# SERVICE BULLETIN

SUBJECT: Aerobatic oil trap, crankcase breather.

# SERVICE BULLETIN

SUBJECT: SAFETY HARNESS UPPER ATTACHMENT

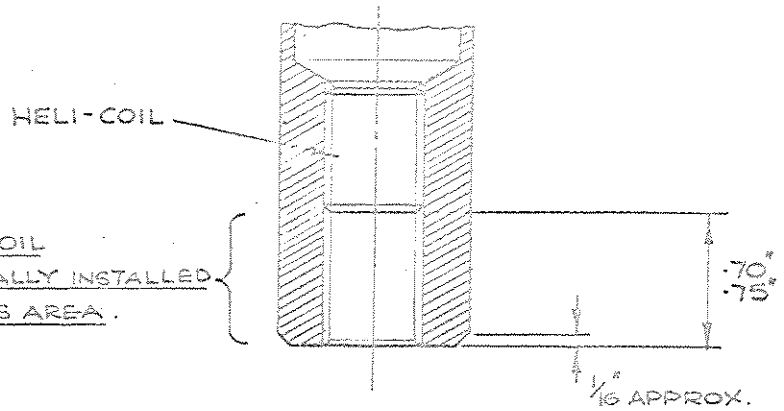
Advance toward final dimension slowly. Winding it another half turn inwards is not difficult, but it is not possible to turn the heli-coil backwards if it is inserted too deeply.

(v) Break off tang of insert by tapping with a rod having a diameter that fits into the insert.

(vi) Repeat installation on other side.

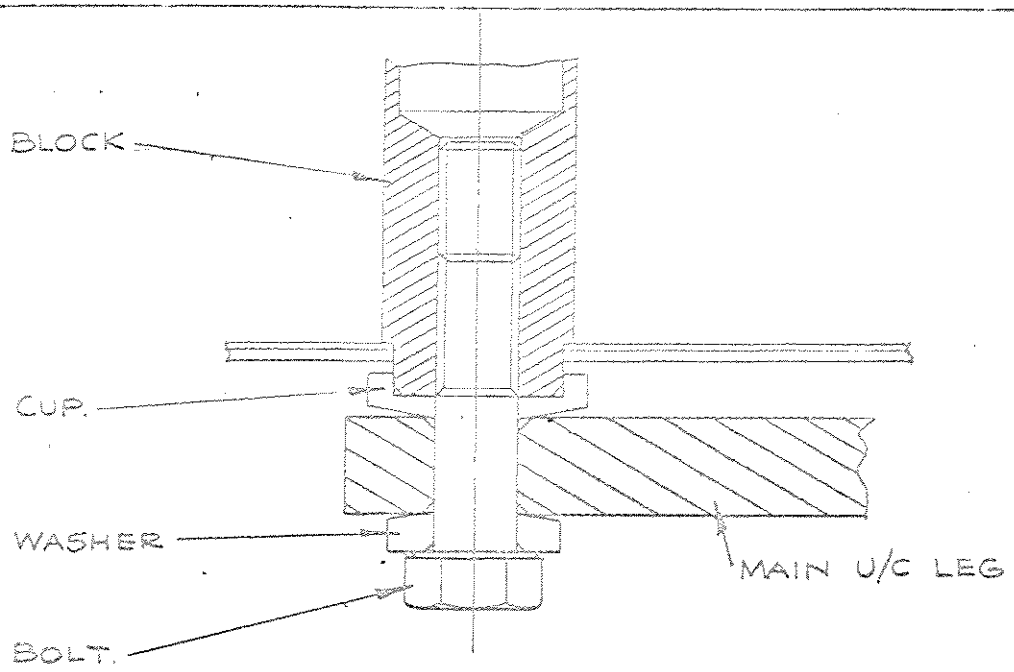
(vii) Re-instal main landing gear in accordance with Maintenance Manual, chapter 16, Part 3. Use conical cup, Part No. 02-61034/1, conical washer Part No. 07-61035/1, and bolt Part No. 07-61033/1 as shown.

(i) Ensure washer 02-61035/1 is installed with conical face against leg.

(ii) Delete undercarriage fairing inner attachment bracket Part No. 10043/1 if fitted.

(viii) After 50 hours flying time, drop undercarriage fairings, lift weight off main wheels and re-torque inner attachment bolts to 38-42 ft.lbs. (456-504 in.lbs) with dry thread. Lockwire and replace fairings.
